Transport Assessment

Moorebank Intermodal Precinct West – Stage 3 (SSD 10431)
(Response to Submissions)

Ref: P1277r02v1
28/07/2020

Table 2: Response to TfNSW Submission

Figure 5: Network Traffic Volumes, with MPW S2 - Scenario 2

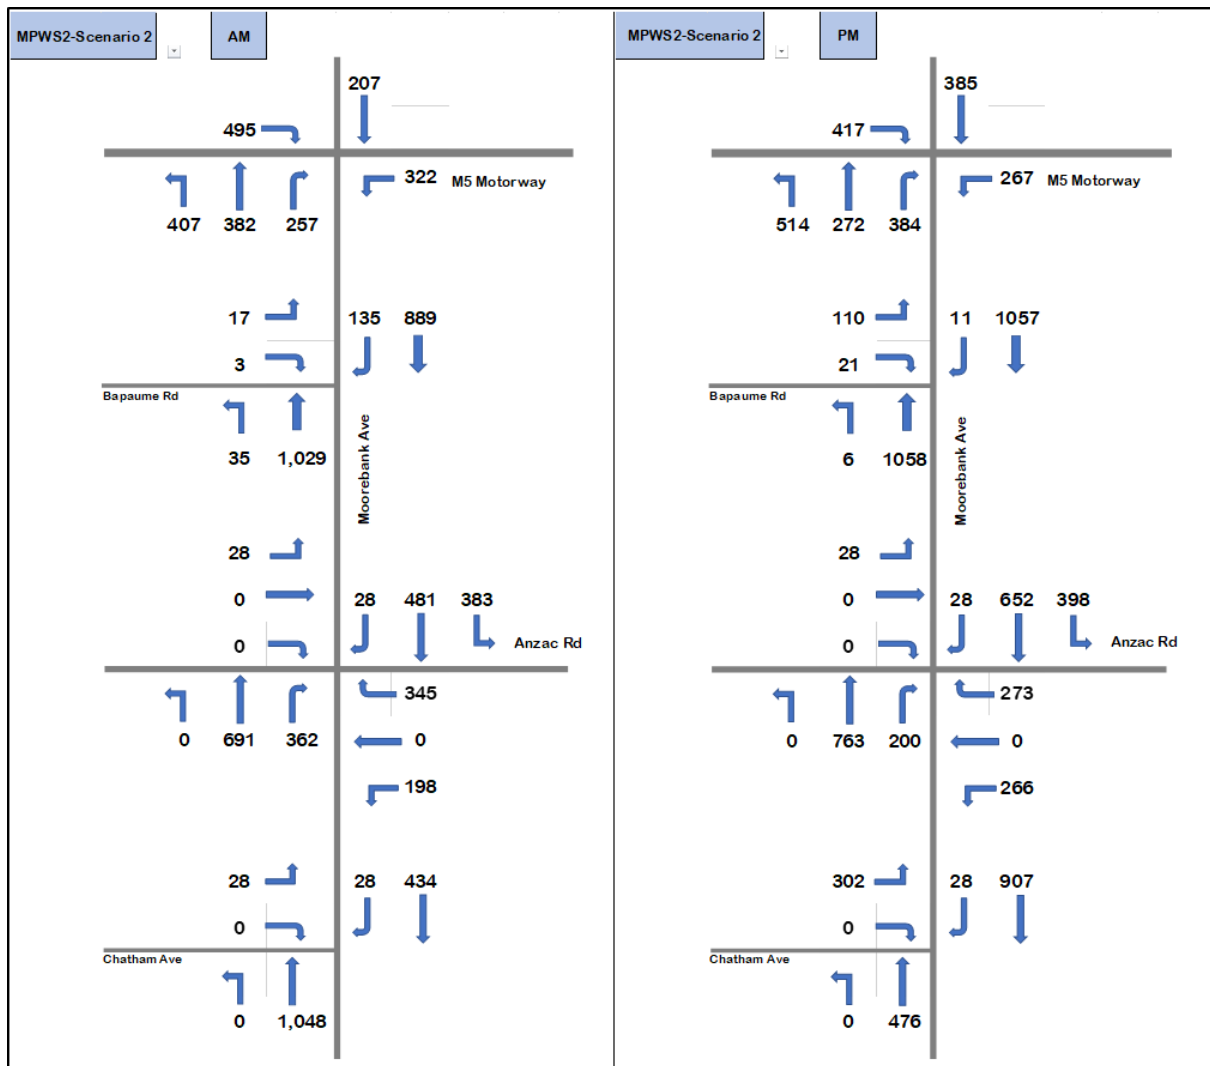
TfNSW Comments	Ason Group Response
<p>Network Traffic Volumes, with MPW S2 - Scenario 2</p> <p><u>Comment</u></p> <p>It is noted that Figure 5 of the Transport Assessment prepared to support the development application states that the traffic volumes included in Figure 5 are based on the Moorebank Precinct West (MPW) Stage 2 Proposal - Construction Traffic Impact Assessment, dated October 2016 (2016 MPW Report).</p> <p>It advised that:</p> <ul style="list-style-type: none"> Based on the traffic distribution adopted for Stage 2-Scenario 2 in Figure 5 of the Transport Assessment, number of construction vehicle movements included in Figure 5 are lower during the morning peak period and higher during the afternoon peak period compared to the construction traffic movements reported in the 2016 MPW Report; and Morning and afternoon traffic movements for Stage 2-Scenario 2 included in Figure 5 are not the same as traffic movements included in 2016 MPW Report for this scenario. <p><u>Recommendation</u></p> <p>It is requested that the applicant clarifies the apparent inconsistencies between the Transport Assessment Report and the Moorebank Precinct West (MPW) Stage 2 Proposal - Construction Traffic Impact Assessment, dated October 2016</p>	<p>TfNSW (and other submissions) are referencing an earlier 2016 CTIA report, whereas the submitted report relies on the later 2017 Response to Submissions CTIA report volumes—see below.</p> <div data-bbox="900 775 1358 1417"> </div> <p>For clarity, the figures adopted came from Figure A-5 and A-6 of that report by Arcadis.</p>

Figure 6: Construction Access Route Comparison

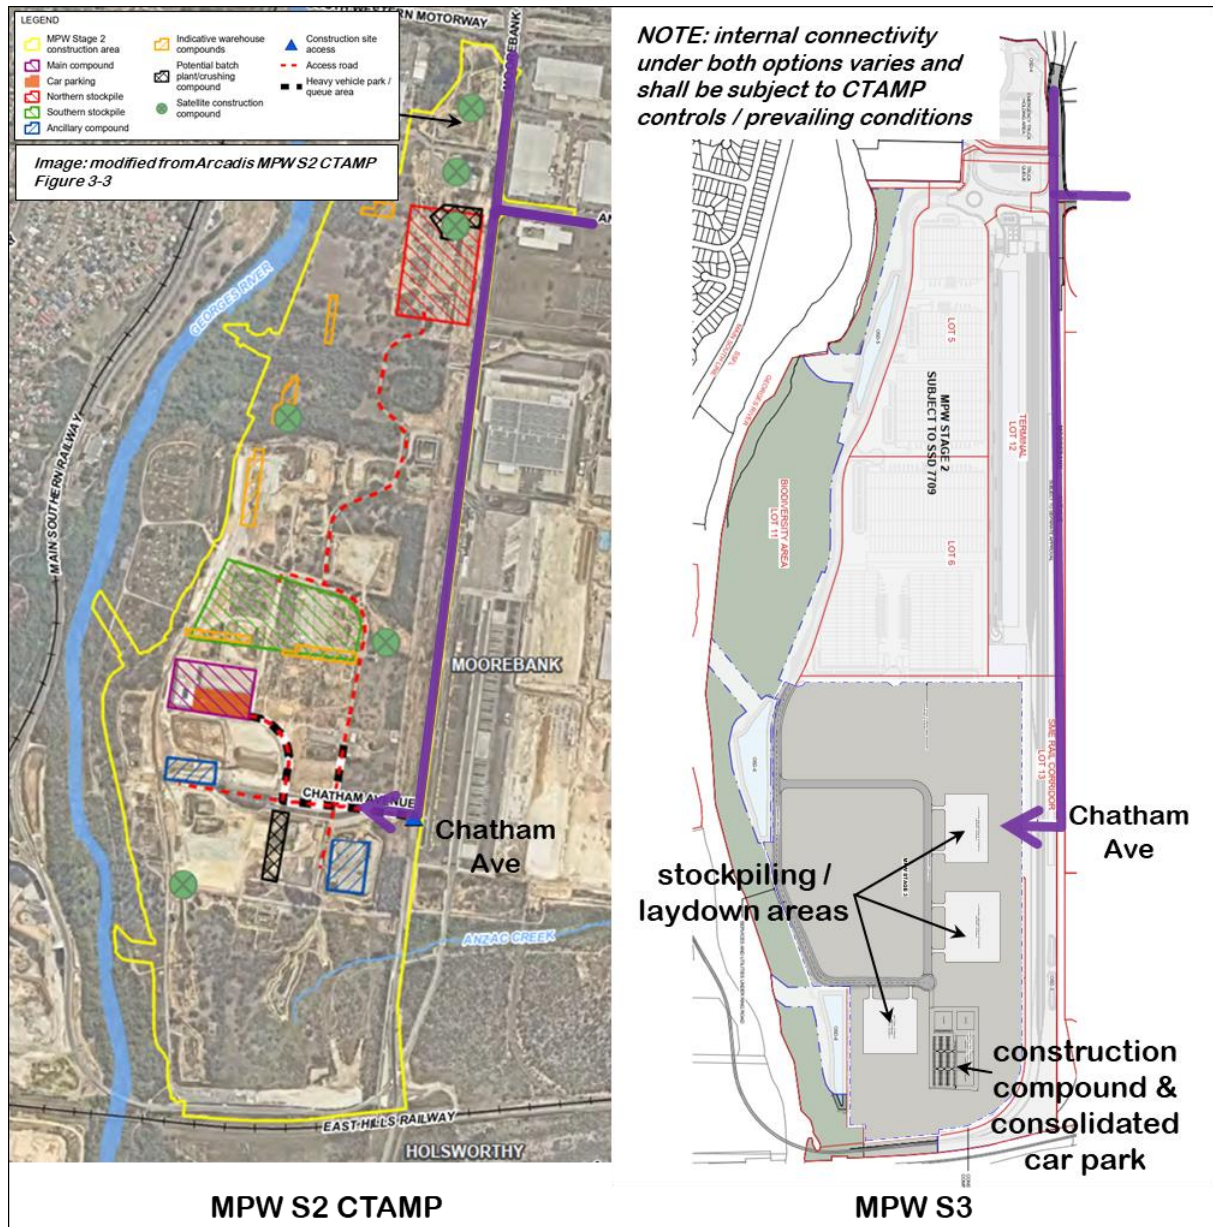
TfNSW Comments	Ason Group Response
<p>Impacts on the Moorebank Avenue/Anzac Road Intersection</p> <p><u>Comment</u></p> <p>It is noted that Section 3.2 of the Transport Assessment states the following:</p> <p><i>“Removal of the Chatham Avenue site access for MPW construction site access during later stages of MPW construction (Works Period C through to completion)”</i></p> <p>It is also noted that Section 3.3 of the Transport Assessment states the following:</p> <p><i>“The proposed changes will not have a material impact off-site, with all construction traffic still traversing the MPW precinct access at Anzac Road, noting that there are specific controls in place to restrict construction vehicles from using Moorebank Avenue to the south. There is expected to be some localised redistribution of construction vehicle movements,”</i></p> <p>It is advised that the redistribution of traffic as a result of the closure of Chatham Avenue access would have the potential to impact on the operation of the Moorebank Avenue/Anzac Road intersection.</p> <p><u>Recommendation</u></p> <p>It is requested that the applicant undertakes traffic modelling as part of the applicant's Response to Submissions to confirm that the proposed removal of Chatham Avenue access would not have a material impact on the operation of the Moorebank Avenue/Anzac Road intersection.</p>	<p>As discussed in Section 1.3 of this report, the Chatham Avenue access is to be retained throughout construction of MPW Stage 3.</p> <p>As such, the proposal is now effectively unchanged from that of the approved MPW Stage 2 and additional traffic modelling is not required.</p>
